UNITED STATES PATENT AND TRADEMARK OFFICE

APPLICATION NO.	FILING DATE	FIRST NAMED INVENTOR	ATTORNEY DOCKET NO.	CONFIRMATION NO.
10/583,607	06/20/2006	Jun Nishikawa	09812.0098	2625
22852	7590	08/05/2011	EXAMINER	
FINNEGAN, HENDERSON, FARABOW, GARRETT & DUNNER LLP 901 NEW YORK AVENUE, NW WASHINGTON, DC 20001-4413			JOHNSTON, PHILLIP A	
			ART UNIT	PAPER NUMBER
			2881	
			MAIL DATE	DELIVERY MODE
			08/05/2011	PAPER

Office Action Summary

Detailed Action

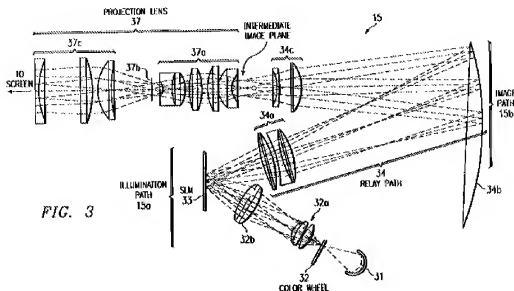
7. Regarding claim 14, Davis discloses at Col. 3, line 38-67; and Col. 4, line 1-33; the projection display apparatus shown below in Figure 3 that includes the following;

(a) Light source 31,

(b) Modulator SLM 33 that modulates the light source based on digitized video signals. See Col. 3, line 22-37

(c) A first optical system that includes the following optical elements; lens set 34a, concave mirror 34b and lens set 34c, which forms an intermediate image of SLM 33 (the primary image surface) at the intermediate image plane, of lenses 34a as shown in Figure 3 above. Col. 4, line 16-33,

(d) A second optical system that also utilizes concave mirror 34b and the optical elements of Projection Lens 37 (note Figure 3 above) to create an image on the display system screen (the secondary image surface). Col. 4, line 16-33,

(e) An optical path represented by the three ray bundles shown in Figure 3 above, which reflect from the center and extremities of modulator SLM 33 (the primary imaging surface Col. 1, line 27-43), where the light first crosses the optical axis in light path 34 then reflects off the concave mirror 34b and crosses the optical axis again at the intermediate image plane then travels through the projection optics to the screen (the secondary image surface). See Col. 3, line 38-67; and Col. 4, line 1-33.

Davis discloses a projection display apparatus shown above in Figure 3 that includes the following;

(c) A first optical system that includes the following optical elements; lens set 34a, concave mirror 34b and lens set 34c, which forms an intermediate image of SLM 33 (the primary image surface) at the intermediate image plane, of lenses 34a as shown in Figure 3 above. Col. 4, line 16-33,

(d) A second optical system that also utilizes concave mirror 34b and the optical elements of Projection Lens 37 (note Figure 3 above) to create an image on the display system screen (the secondary image surface). Col. 4, line 16-33,

(c) An optical path represented by the three ray bundles shown in Figure 3 above, which reflect from the center and extremities of modulator SLM 33 (the primary imaging surface Col. 1, line 27-43), where the light first crosses the optical axis in light path 34 then reflects off the concave mirror 34b and crosses the optical axis again at the intermediate image plane then travels through the projection optics to the screen (the secondary image surface). See Col. 3, line 38-67; and Col. 4, line 1-33.
